TIS Service Bulletin Page 1 of 6

FOUL, MUSTY ODOR FROM HVAC: WET FOOTWELL CARPET

This Service Information bulletin replaces SI M64 01 11 dated October 2017.

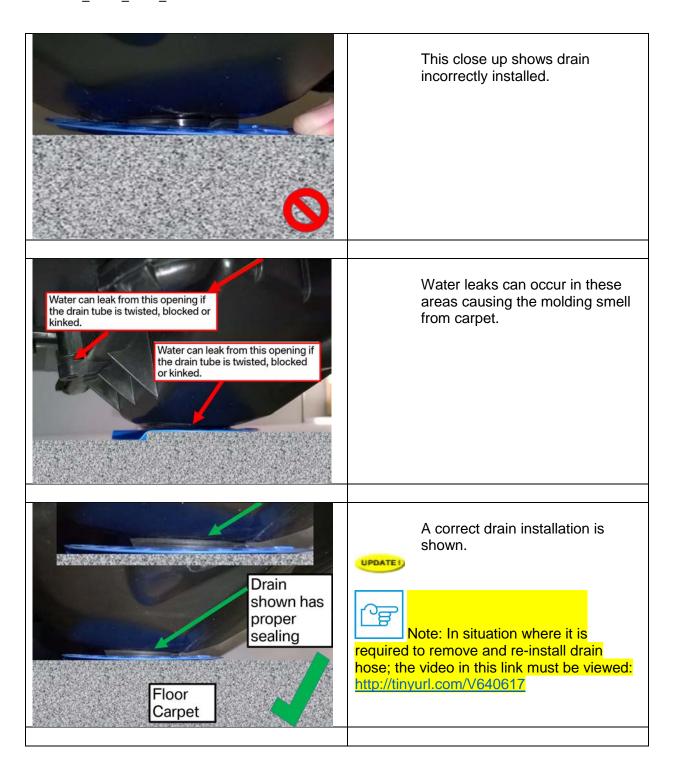
Drain shown is twisted and deformed.

Prepare (modify) drain by cutting the flap and lower section approximately 30 mm. This will prevent future blockage.
